The request is to acquire right-of-way (ROW) for the reconstruction of Glenn Hwy MP 53-56, Project #OA15025/Z5801130000 (**Exhibit A & B**). A fact sheet from the project website is at (**Exhibit C**)

RIGHT-OF-WAY MAP

**GLENN HIGHWAY MP 53 TO 56
RECONSTRUCTION
MOOSE CREEK CANYON
OA15025/Z580130000**

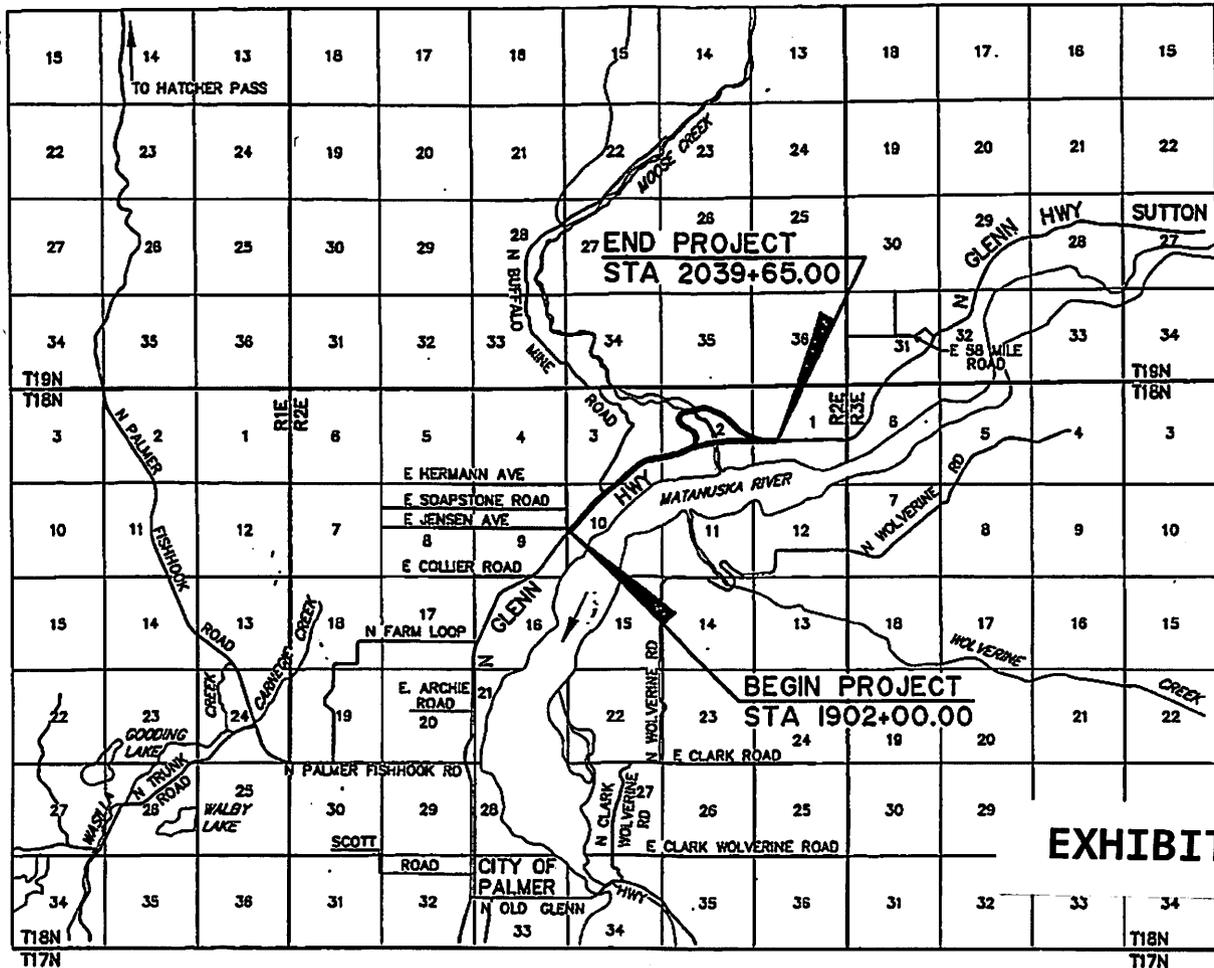
I noticed on the project map that many of the existing parcels and remainder parcels are listed as "Large" in the Parcel Information tables. Are these areas expected to be given a square footage when the acquisition is finalized?

ARRC has no objections to this plat. However, we would like to more fully explain the nature of proposed acquisition parcels P15, and P17.

ARRC typically includes under the agreement only the areas necessary for the existence, use, and maintenance of the DOT facility and not necessarily a full uniform ROW width. One condition for including a new facility in this agreement is that the new construction must comply with the ARRC "Technical Standards for Roadway, Trail, and Utility Facilities in the ARRC Right-of-Way". Since the design of the DOT facility is not complete, ARRC has to date been unable to assess compliance with these standards. Once compliance is achieved ARRC will ultimately include, under the agreement, some portion of the land area within P15 and P17 as a grade separated crossing. The specific limits of the facility-area have not yet been defined Since DOT has not yet completed its design.

There are several reasons why a larger, non-specific, area is shown.

1. The parcel has never been surveyed but has been platted by protraction, such as a BLM lotting (aliquot part or Govt. Lot).
2. The parcel was created via a borough waiver and not surveyed.
3. The parcel abuts a water boundary which makes for an interpretive boundary and area.
4. The parcel boundary has not been surveyed by DOT or it's boundary is subject to interpretation.

The parcel tables remain as shown in the final, except a recording document number is added.
